BOOM HOSE ADAPTER

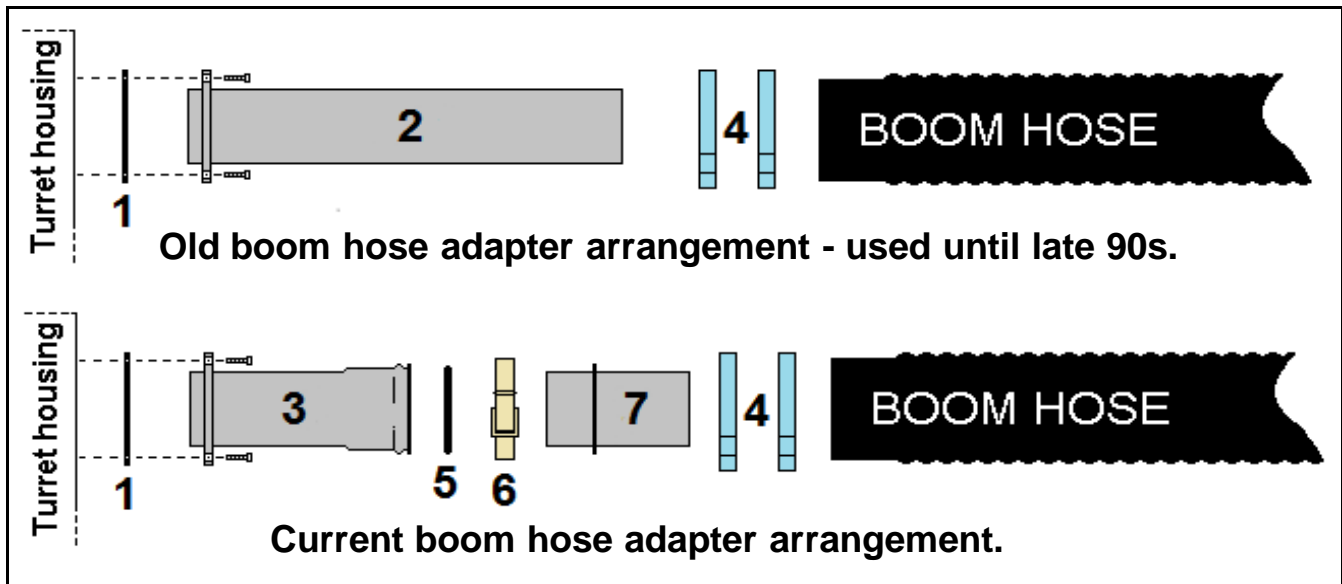
On earlier model Aquatech 8" standard booms, the boom hose clamped directly to the boom hose adapter. Starting in the late 1990s, a quick release design was incorporated making it a much easier task to service the boom hose. The chart below illustrates the difference and calls out the part numbers involved. When ordering parts for a late 90s 8" standard boom, it is best to have the customer check which set-up he has.

NOTE: Besides double clamping the boom hose to item 7, we also drill and use three (3) each of the following: A380352 retaining clips, A380354 carriage bolts, A107210 flat washers, and A107016 lock nuts.
